PROPOSED CHANGE NOTICE

2445-44

RE: AURORA FOOD STORE
 2000 ANAQUOD ROAD
 REGINA, SK
 Commission No. 2445

RE: IDF Closet Power

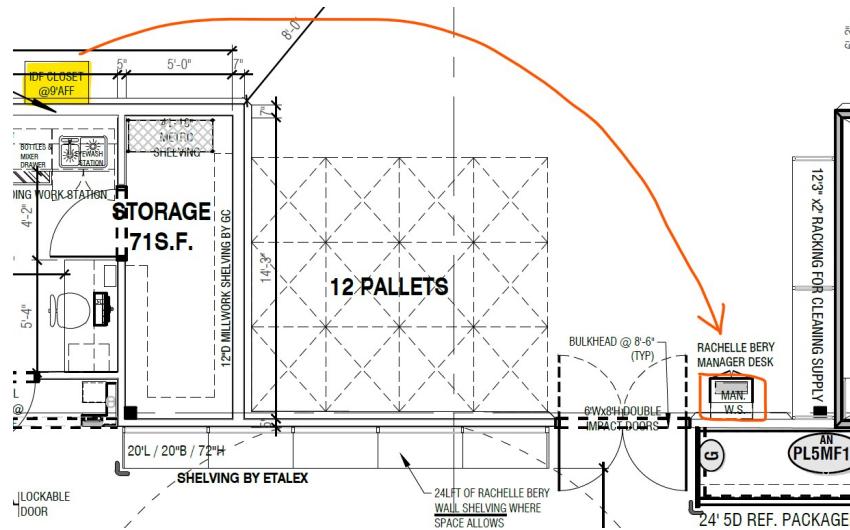
- .1 Modify location of IDF Closet. To be located at 9' AFF above the Rachelle Bery desk:
